UNITED STATES PATENT AND TRADEMARK OFFICE

APPLICATION NO.	FILING DATE	FIRST NAMED INVENTOR	ATTORNEY DOCKET NO.	CONFIRMATION NO.
09/710,362	11/10/2000	John C. Connolly	PLW 13206	5398

Office Action Summary

DETAILED ACTION

Fig. 1

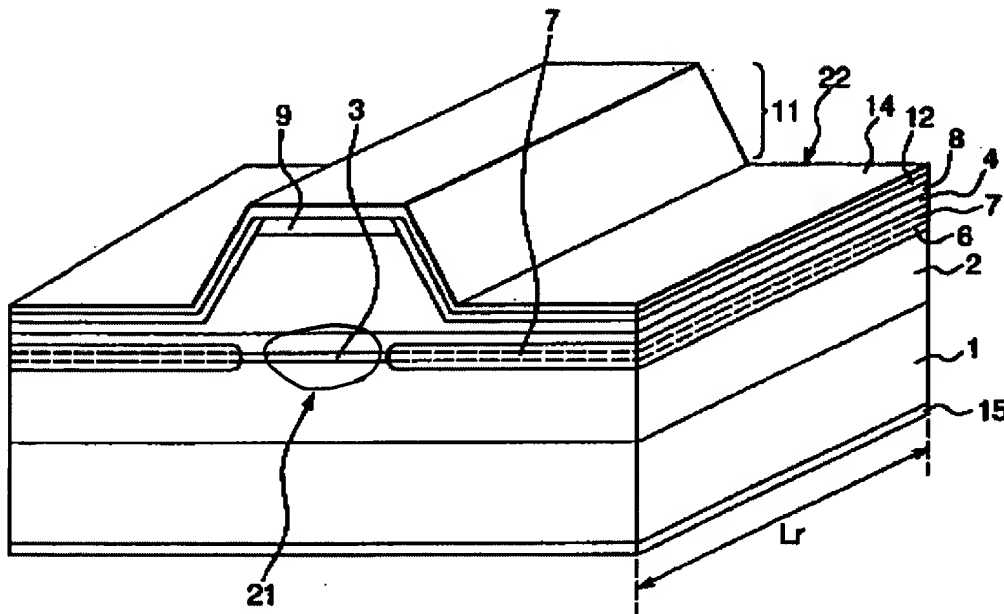
Regarding claim 1, Nagai discloses a ridge waveguide semiconductor laser diode comprising a first conductor layer 14, a second conductor layer 15 facing the first conductor layer, an active layer 3 disposed between the conductor layers, a gain region of the active layer (circled in red below), and reduced conductivity regions 7 of the active layer flanking the gain region and for impeding the passage of current (Fig. 1 and discussion thereof).

Regarding claim 11, an insulator 12 is disposed adjacent to the first conductor layer (see Fig. 1 above).
